PMG Code Action Committee
Working Document for
2023-2026 Code Development Cycle
Page 1 of 21
as of 23MAR2023

TEMPLATE

**Commentary Figure 307.5
EXCAVATION IN RELATION TO FOOTING**

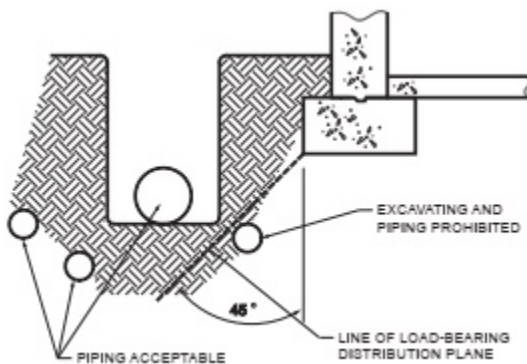
Item 12 ISPSC Minimum horizontal distance of buried pools in relationship to nearby footings.

This would require a new section somewhere in Section 307 GENERAL DESIGN

PHTA might have a task group working on this.

Fred to pull language together.
